BENNINGTON-MOUNT TABOR
COUNTIES OF BENNINGTON & RUTLAND
FIVE BRIDGES ON OR OVER US ROUTE 7

BENNINGTON - MT TABOR
BF BPNT (16)

Submittal No.: 04c: Containment Plans Rev 2, Pages C8A & C11A

ABRASIVE BLASTING CONTAINMENT PLANS, REV. 3

Bridge No. 16N & 16S

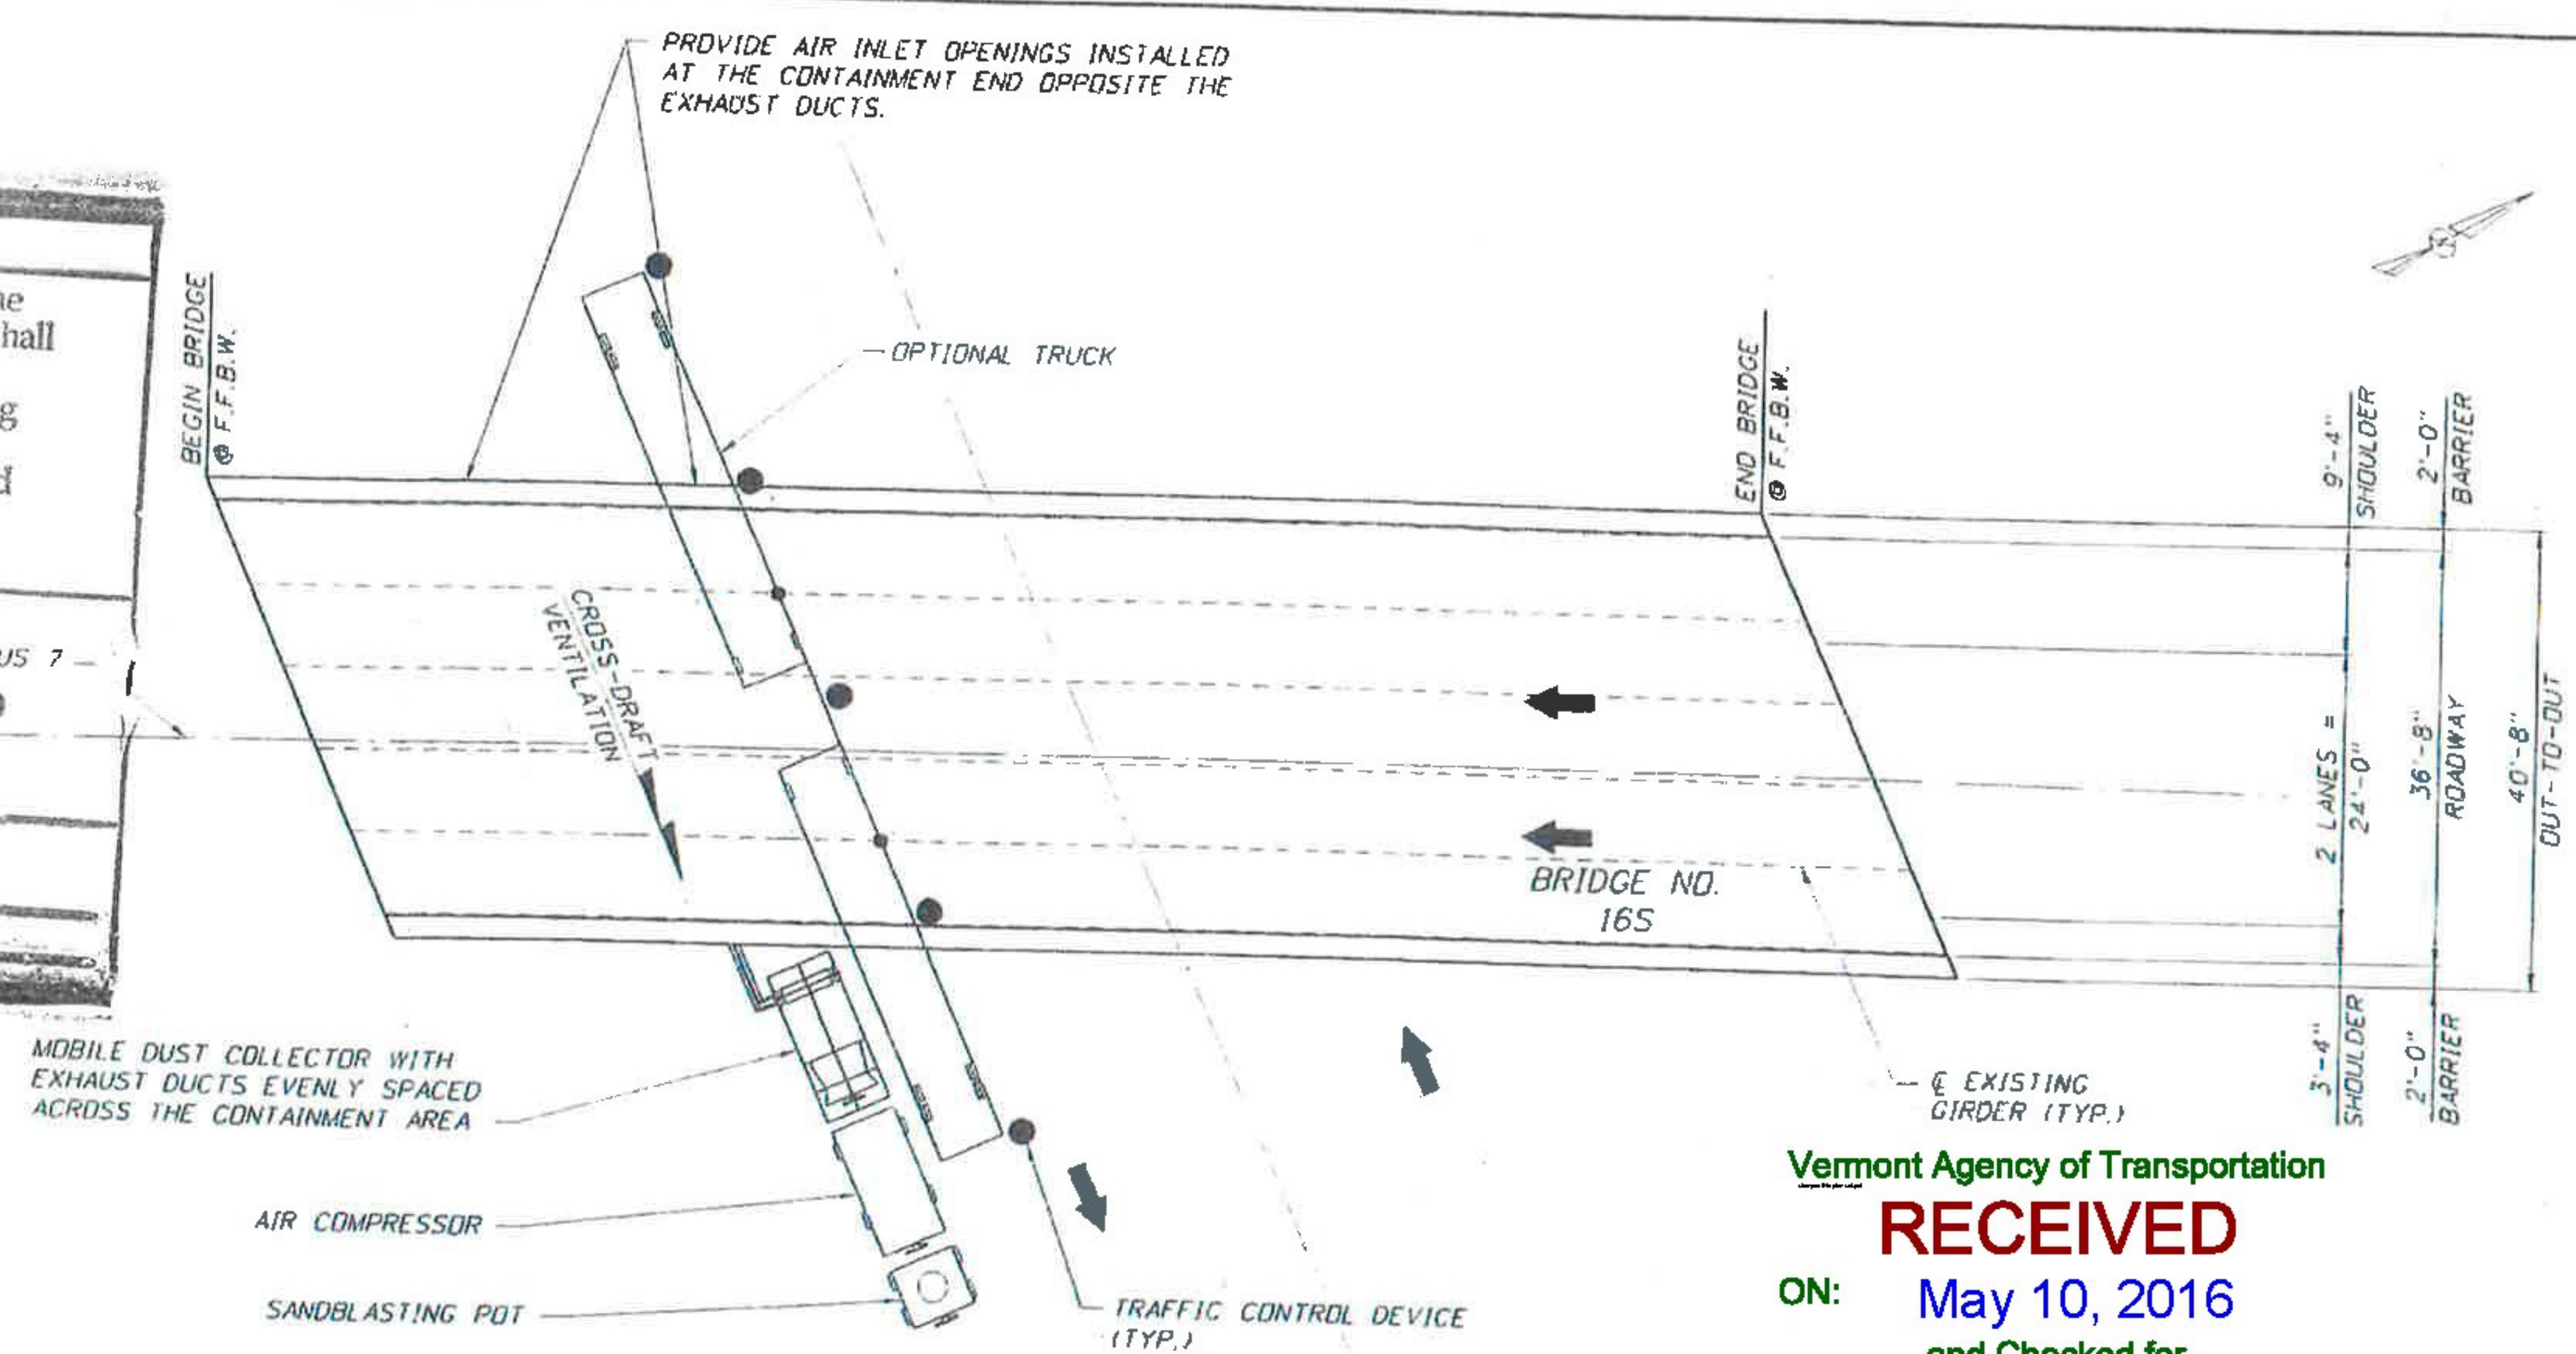
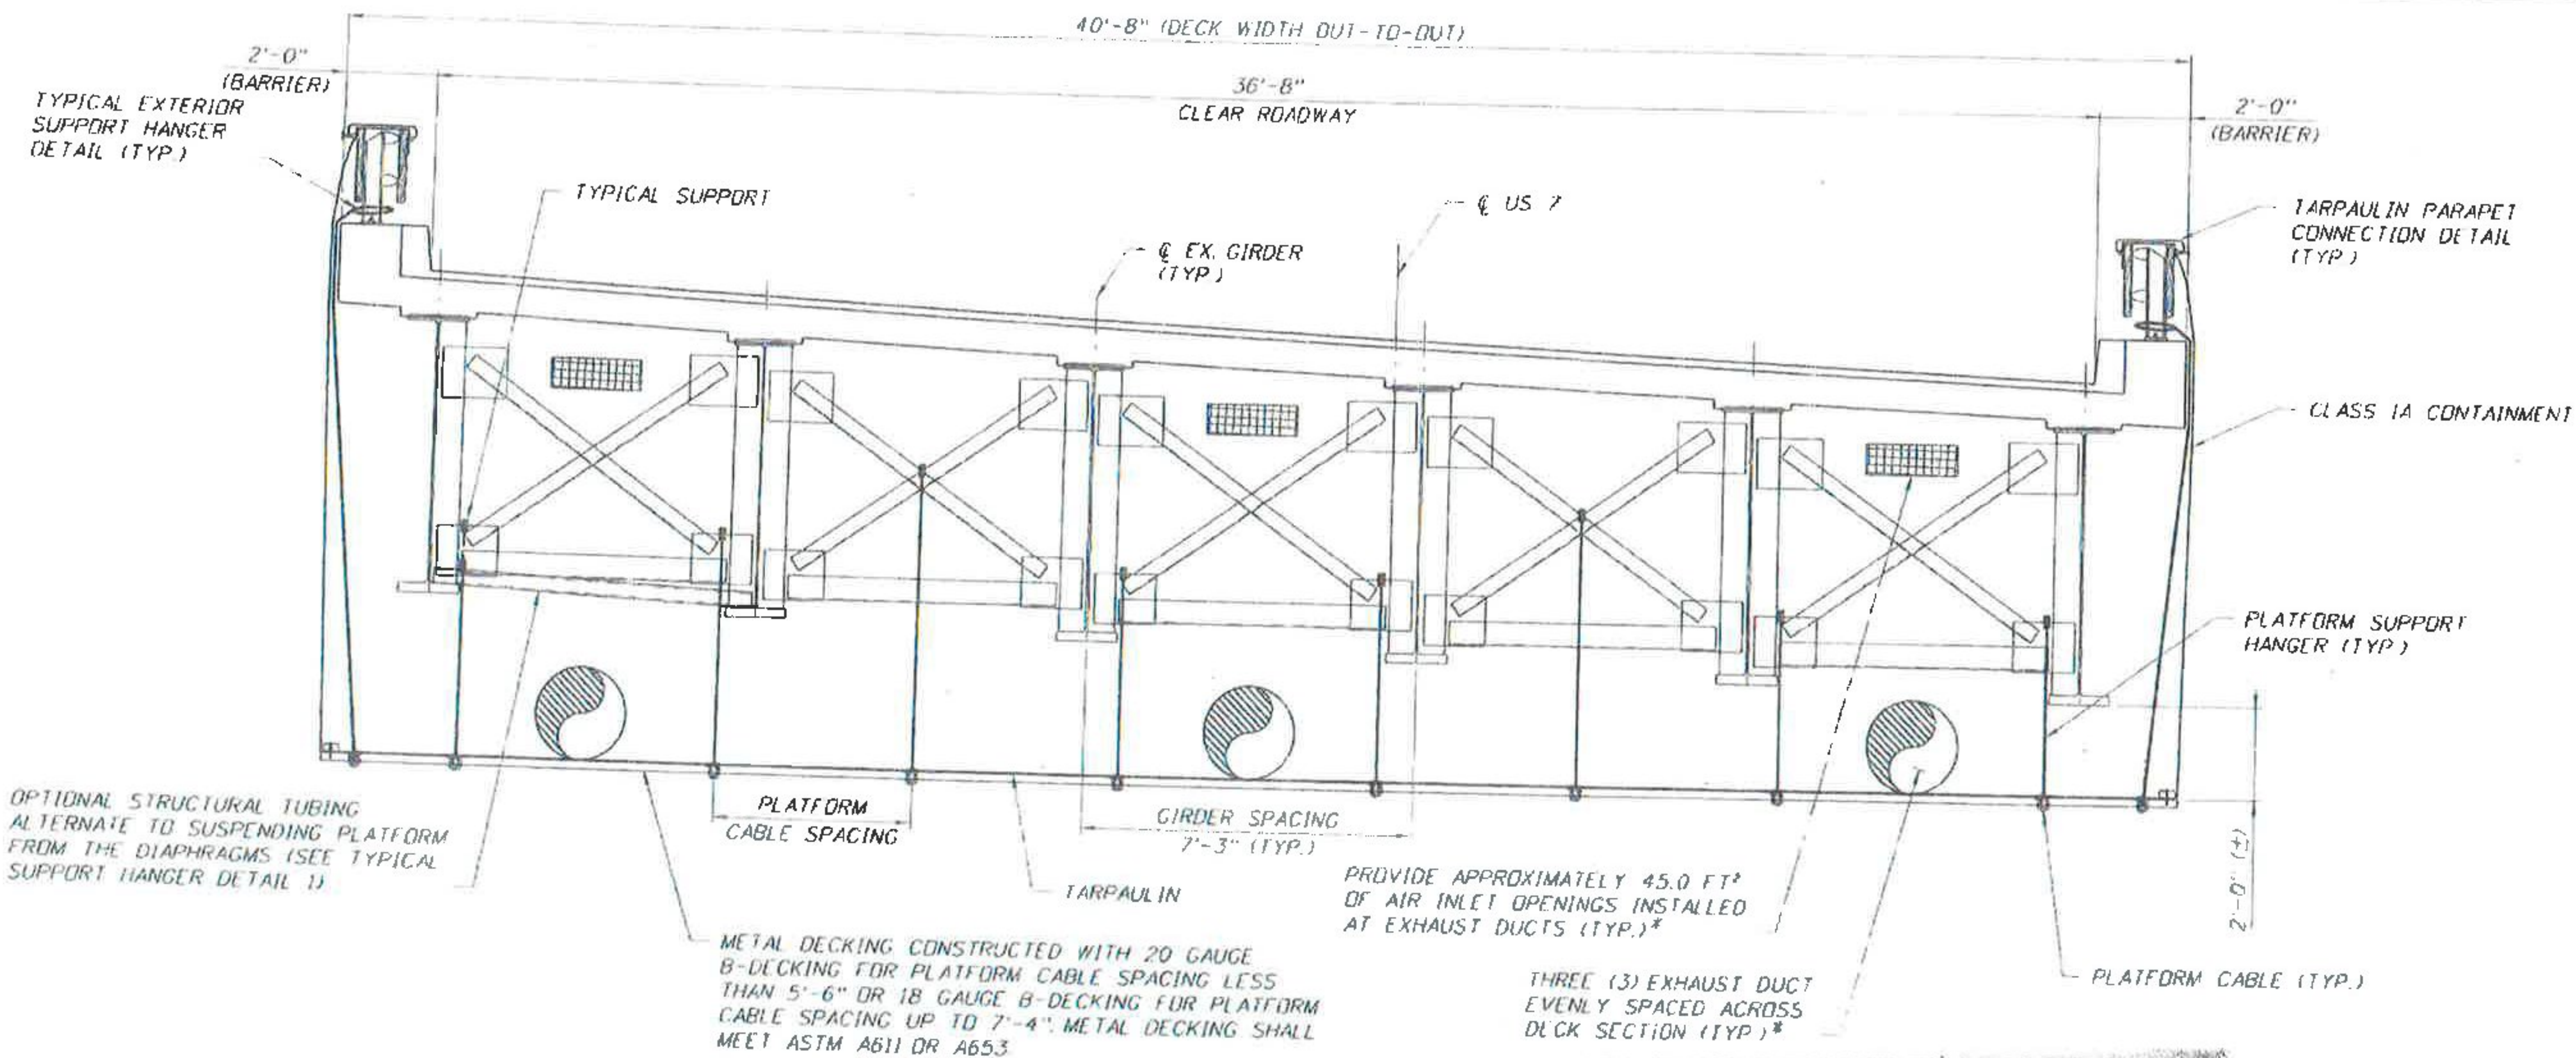
**** USE OF CHAIN LINK FENCE CONTAINMENT IS NOT ALLOWED FOR AREAS OVER LIVE TRAFFIC, BUT MAY BE USED ELSEWHERE.**

- ☐ NO EXCEPTIONS TAKEN
- ☒ MAKE CORRECTIONS NOTED US 7 -
- ☐ RESUBMITTAL NOT REQUIRED
- ☐ AMEND AND RESUBMIT
- ☐ REJECTED - SEE REMARKS

CONTAINMENT SECTION DETAILS (3 OF 3)

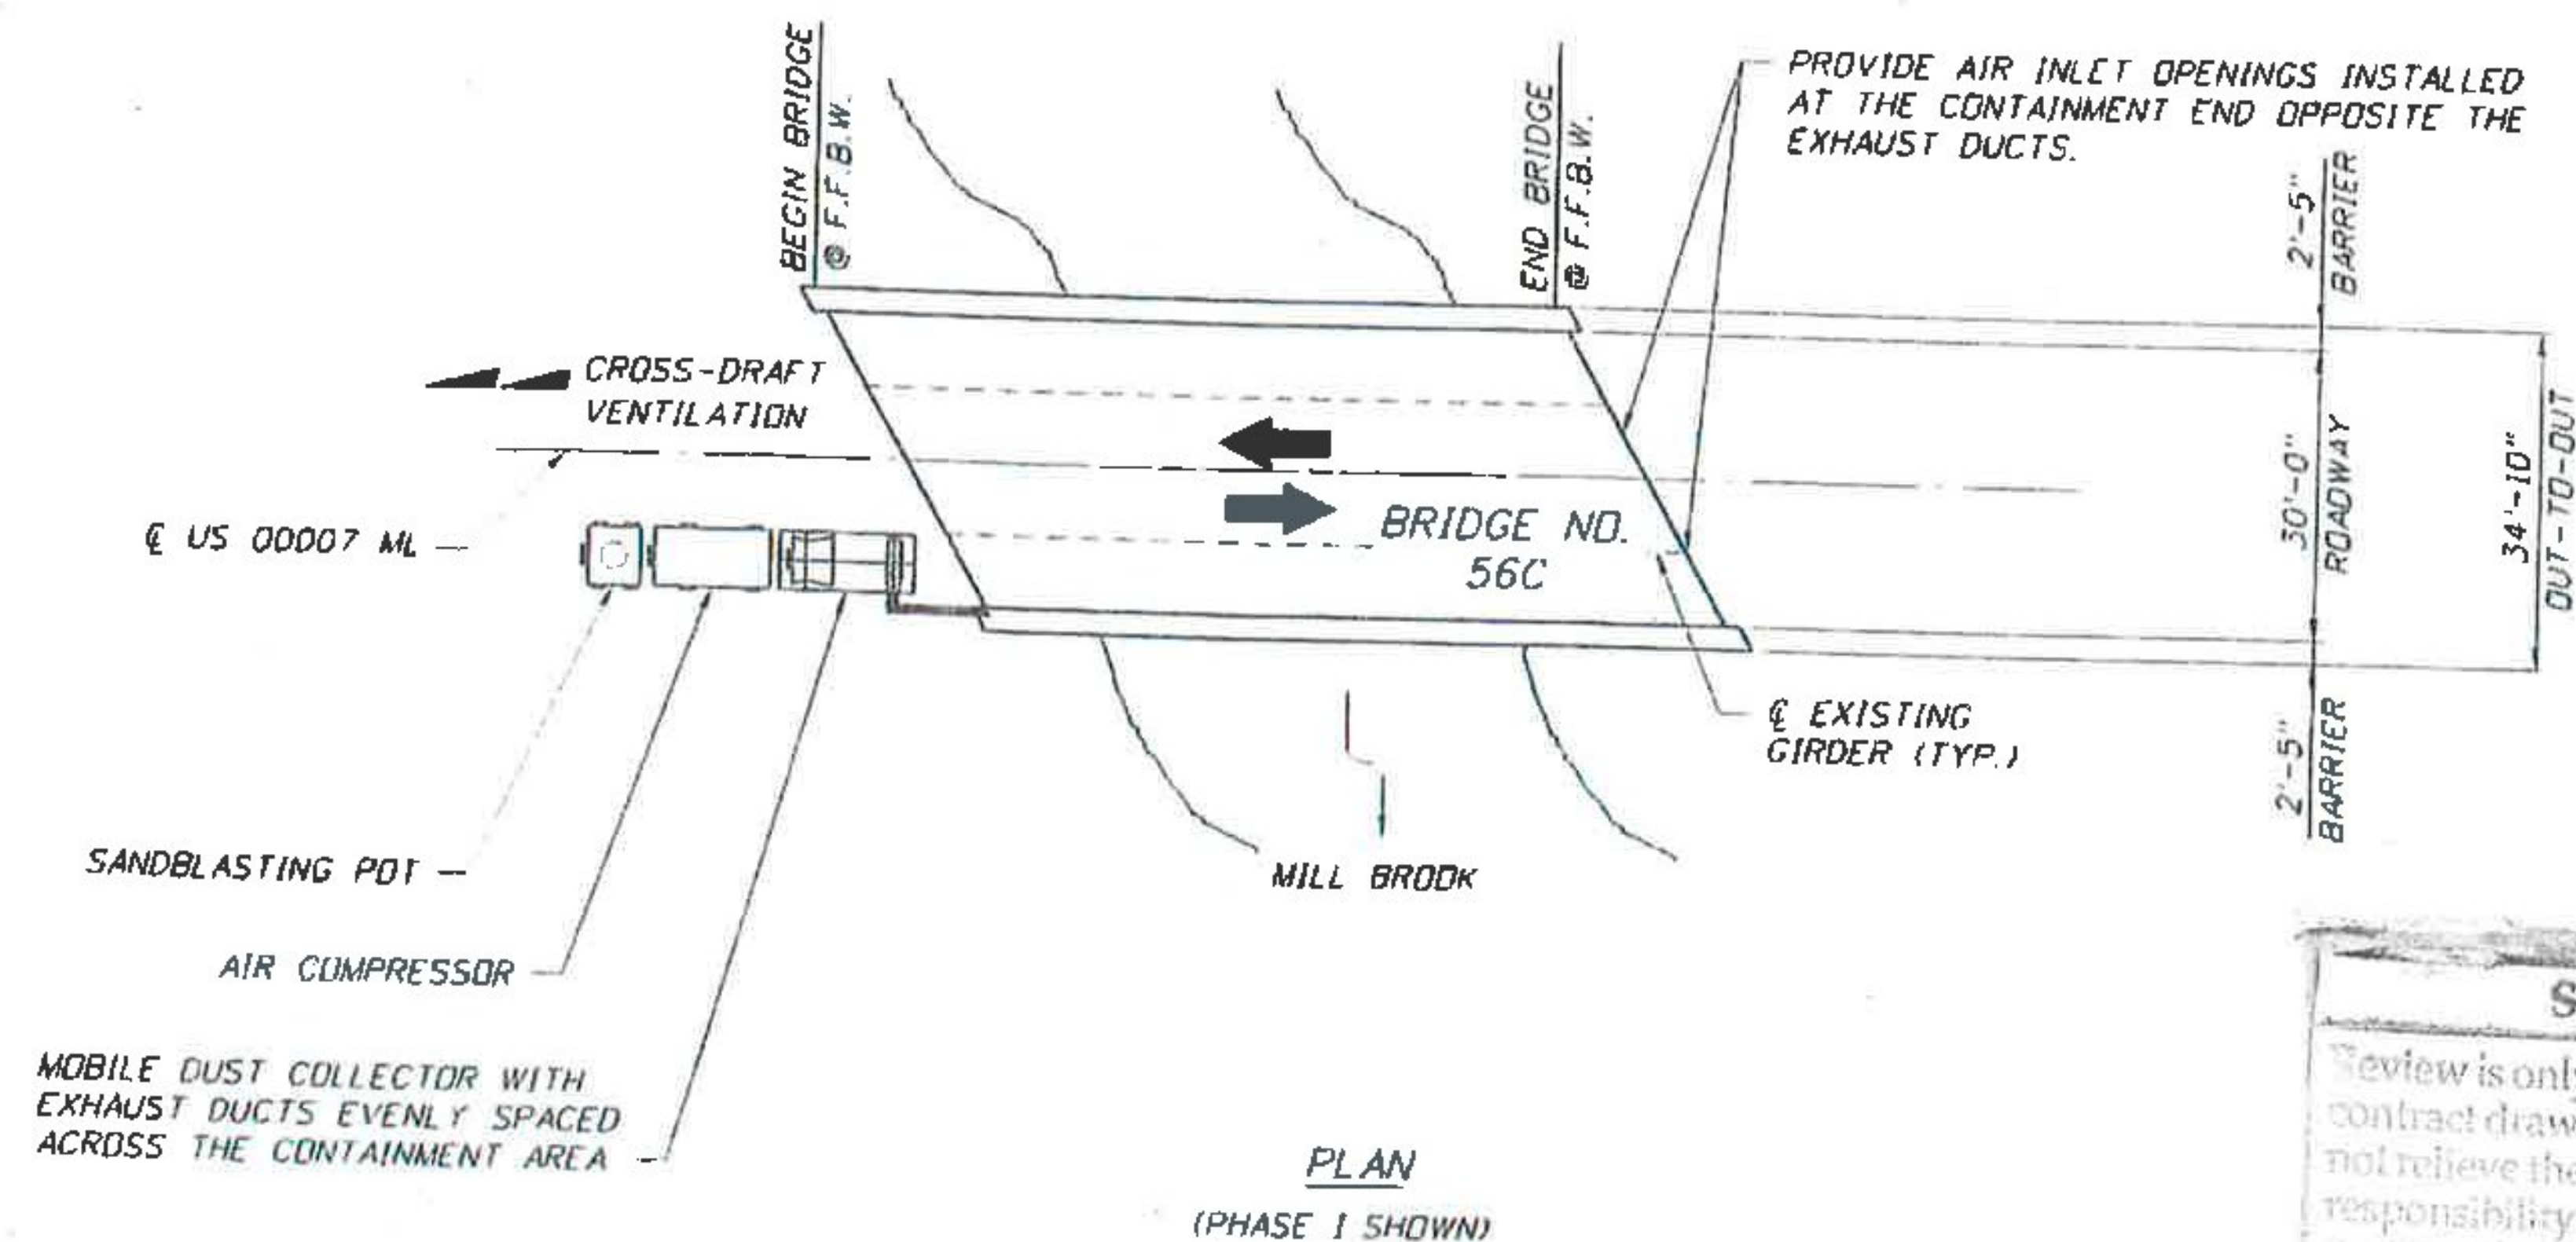
We have added the use of fence platform in conjunction with the corrugated platform for bridges 15 and 16N & S. These pages are shown on C8A & C11A. Note that only corrugated platform will be used over live lanes.
